AREA PLAN AMENDMENT REPORT **Superior Charter Township Board of Trustees**

Sutton Ridge Apartments

Current Report Date: January 15, 2016

Regarding: **Sutton Ridge Apartments**
Area Plan Review #2
OHM Job # 0140-15-1018

EXHIBIT 2 SUTTON RIDGE

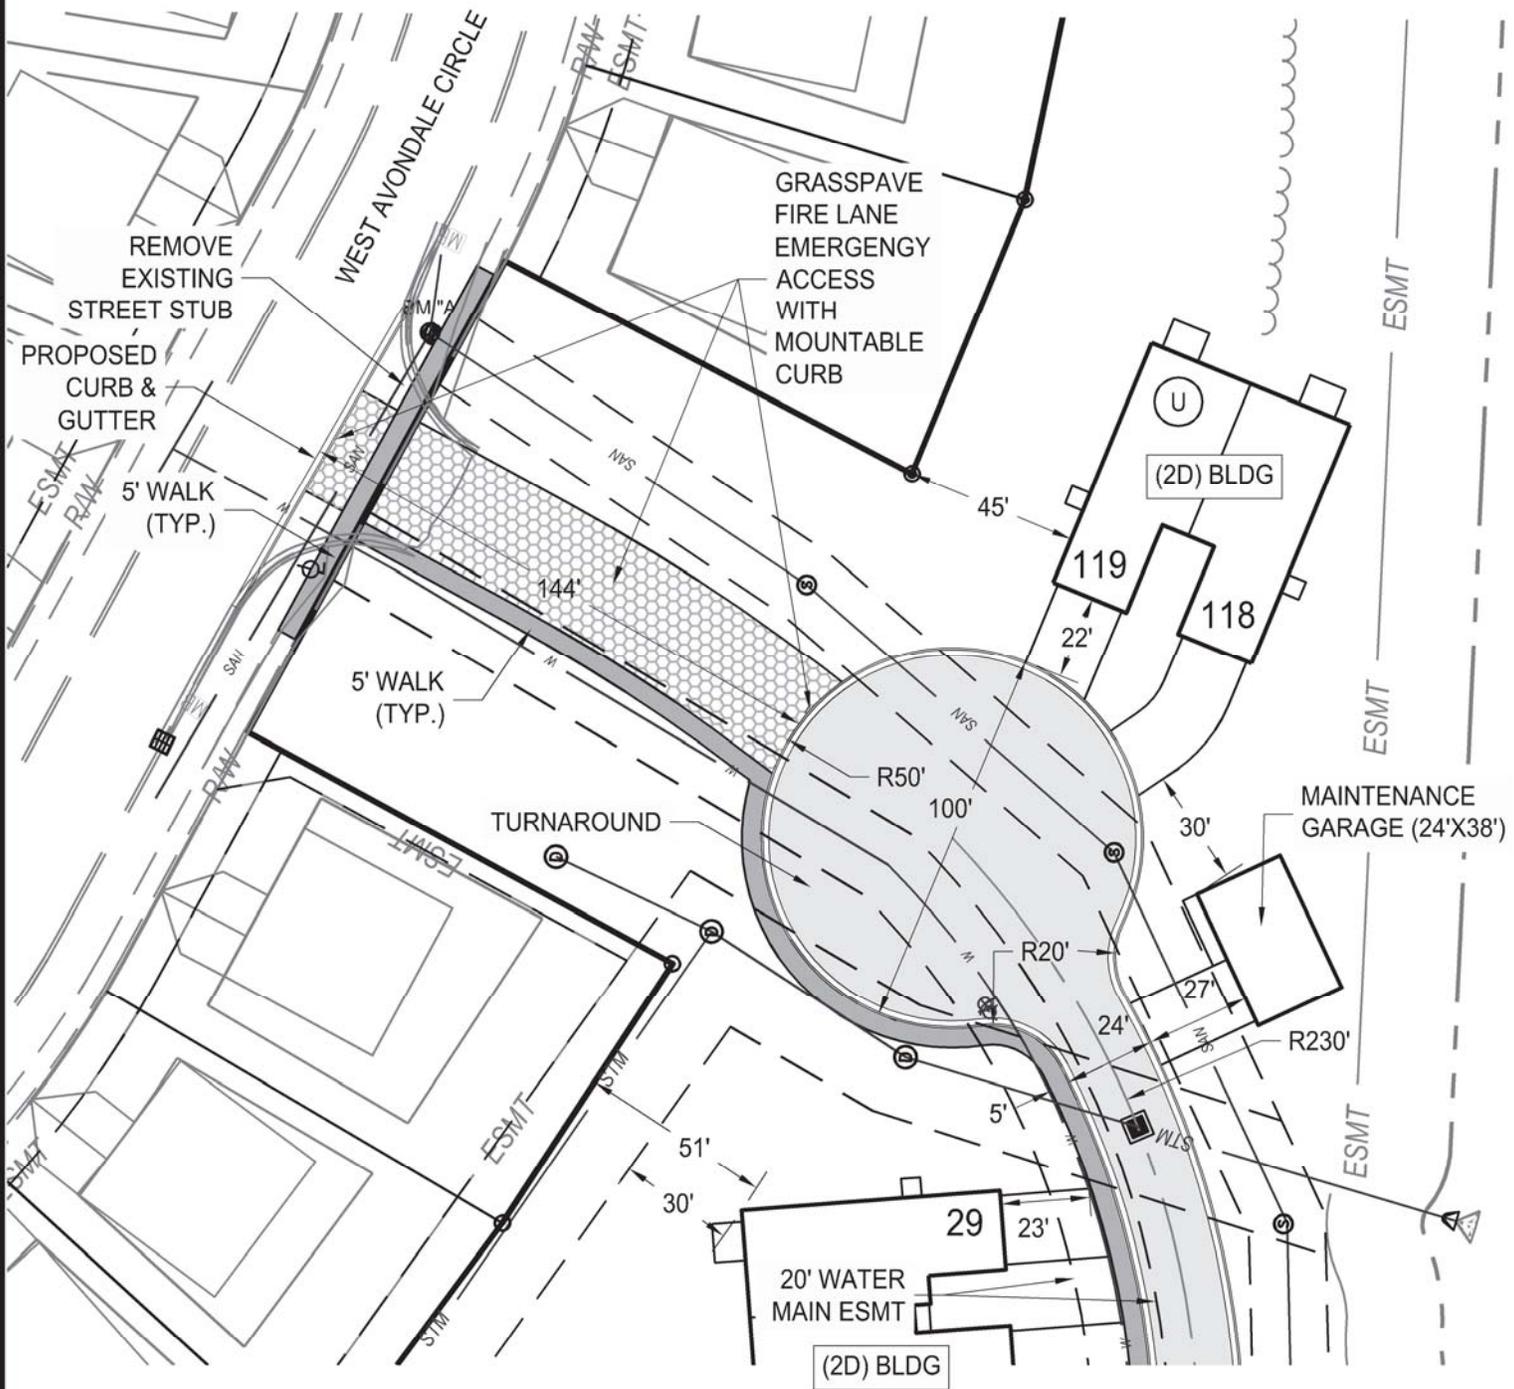
- 5.01 The location of the turnaround area so close to West Avondale Circle and directly between the two adjacent homes has the potential to create noise and headlight-related conflicts with these immediate neighbors when in use. In addition, close proximity to West Avondale may encourage some motorists to cut across the emergency access. For these reasons, we would recommend that the applicant revise the Area Plan to move the turnaround at least 75 feet further to the southwest away from West Avondale Circle.
- 5.02 The inclusion of proposed deviation #6 in the chart on the Sutton Ridge Area Plan cover sheet is potentially confusing, since the applicant also states on the plan that the "*requested deviation is no longer needed.*" We recommend that deviation #6 be deleted entirely from the chart, and the requested deviations renumbered accordingly.

5. We recommend that the applicant consider relocating the cul-de-sac at the end of Drive "C" further to the southwest away from the existing Bromley Park Subdivision homes and extend the emergency access fire lane to connect between Drive "C" and West Avondale Circle. In addition, we recommend that the existing road access return at this location on West Avondale Circle be removed and replaced with a straight section of mountable curb. It is our opinion that this recommendation will help deter motorists from using this connection point that is intended for emergency access only.
